ADDENDUM NO: 03

DATE: 08 April 2025

PROJECT NO: 119.002

PROJECT: Hyde Park Elementary School
333 East 300 North
Hyde Park, Utah 84318

LEVEL 02 AREA 'C' PLUMBING PLAN
P102C 1/8" = 1'-0"

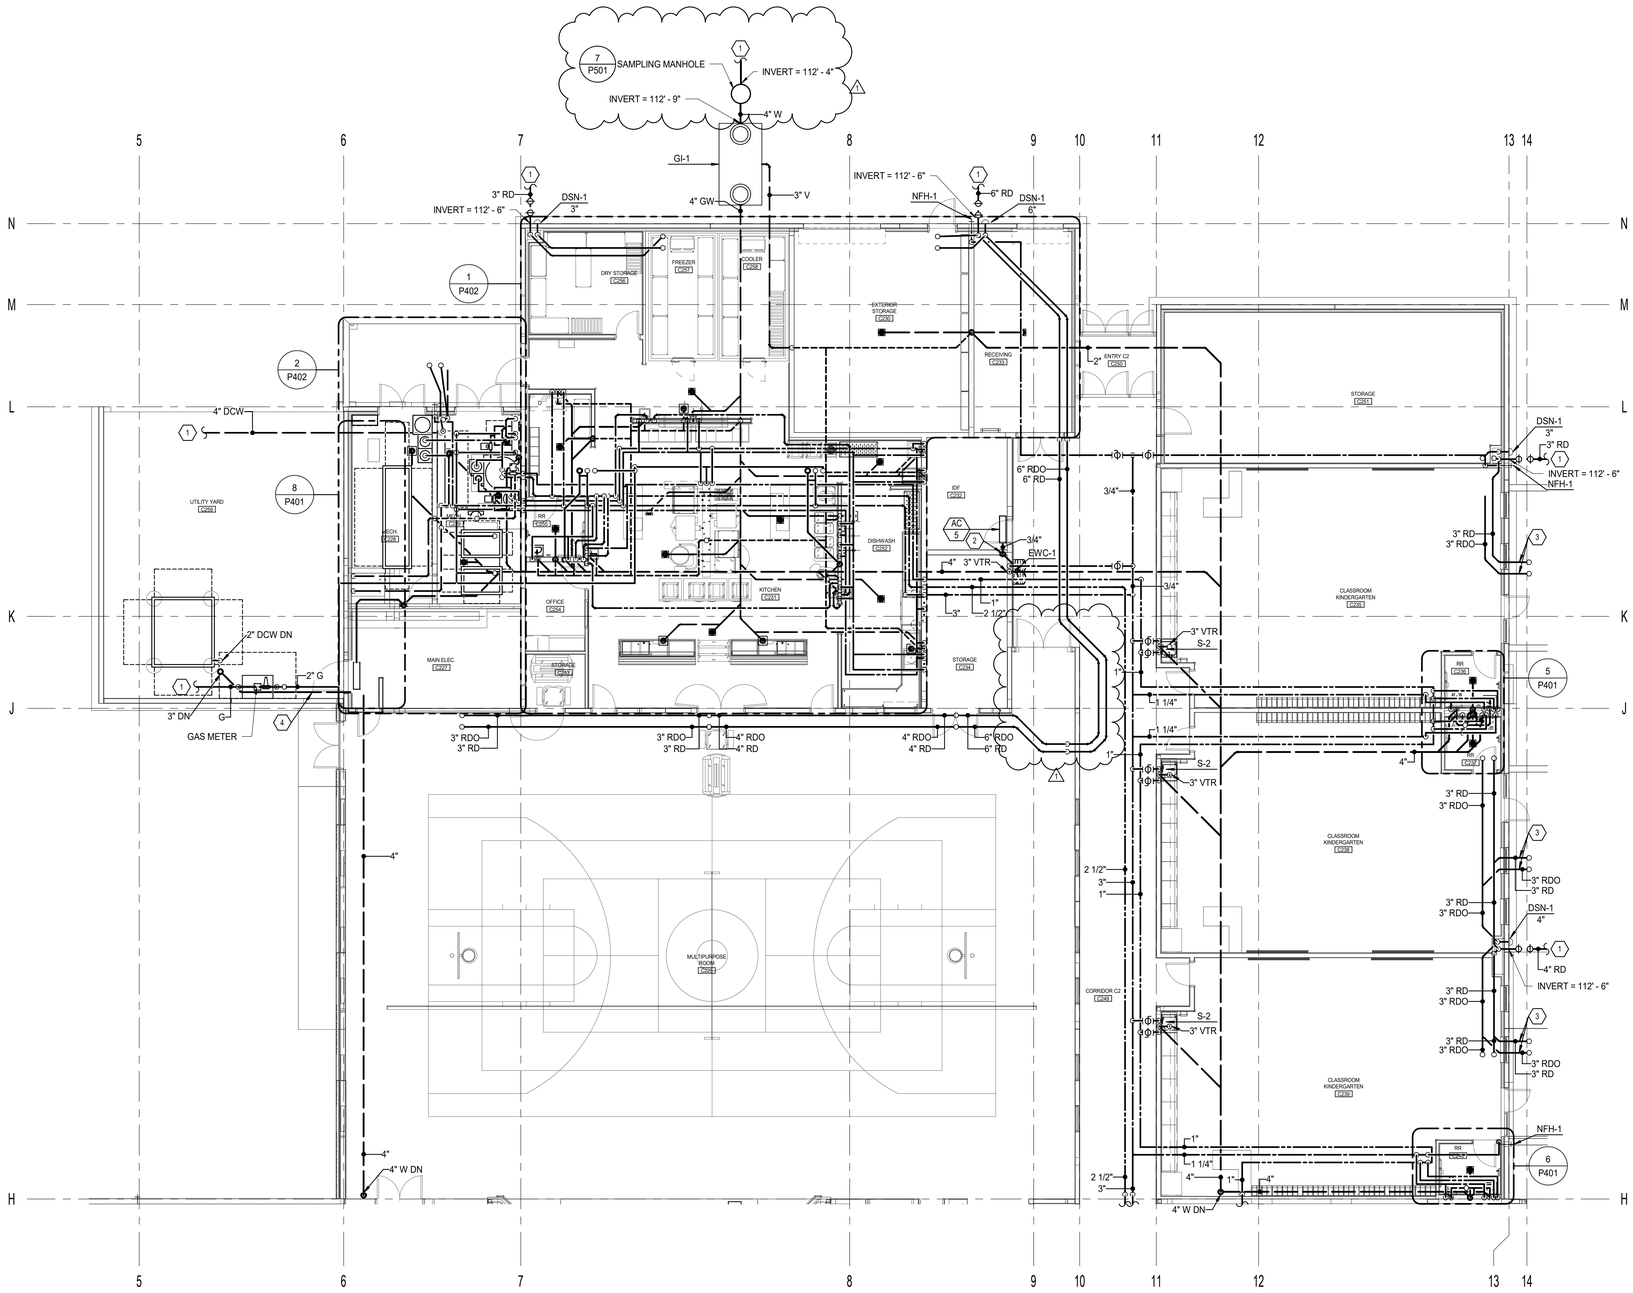
19. Detail 7/P501 shows a sampling manhole for the grease interceptor. This is not shown or reflected on the civil plans. If the sampling manhole is required, please provide specifications including diameter and depth.

VBFA/RESOLUT RESPONSE (20250408): The sampling manhole location will be shown on sheet P102C and shall be of the size detailed on 7/P501.

SHEET TA122 – SECOND LEVEL AUDIOVISUAL PLAN – AREA B

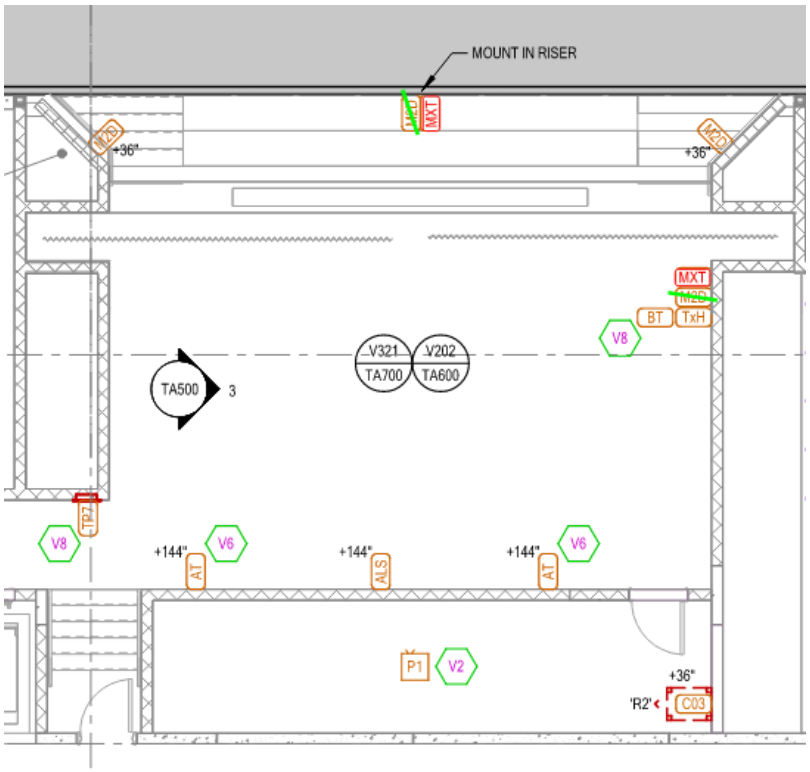
1. Remove all 'M2D' devices shown on the stage area, except the (2) 'M2D' devices on the side walls, and change all 'AXT' devices to 'MXT' (image below).
